Solar Panel Farm, 80 Struie Road, Hororata

Document Date:	03/02/2025
Document Version/Status:	Updated w Addendum
Project Reference:	1087001
Prepared by:	Anne Wilkins, Principal Landscape Architect

TO: Selwyn District Council
FROM: Anne Wilkins | Principal Landscape Architect | Novo Group
PROJECT REF: 1087001
APPLICATION REF: RC246059
STATUS: Post-lodgement \ Addendum to Report \ Updated LVA

S92 RESPONSE: LANDSCAPE AND VISUAL EFFECTS ADDENDUM

02. PLANTING PLAN

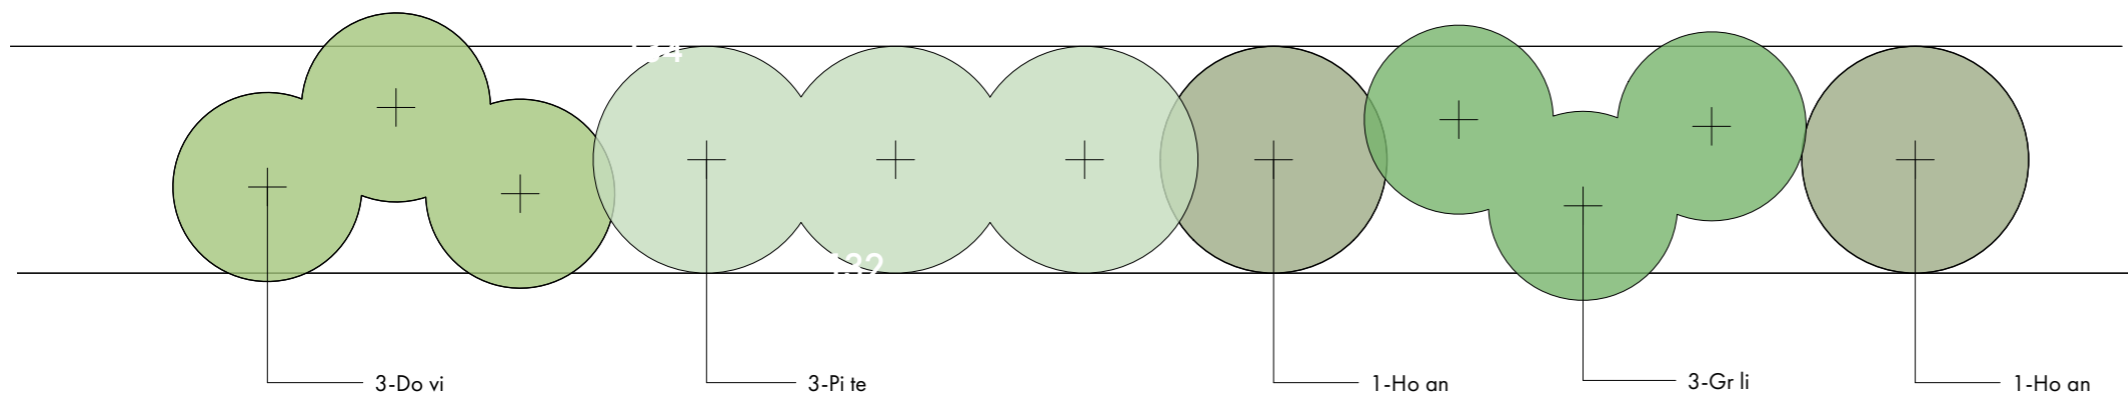
8. **S92 Request (4) Landscape Plan**

10. **S92 Request (5) Plant Establishment**

9. An updated Detailed Landscape Plan has been provided in Appendix 1.

11. Refer to PDP response. Conditions have been offered for planting to be established as soon as practicable after the construction of the panels. The planting species provided for in the updated Detailed Landscape Plan are fast-growing native species that will establish quickly with appropriate maintenance (watering etc).
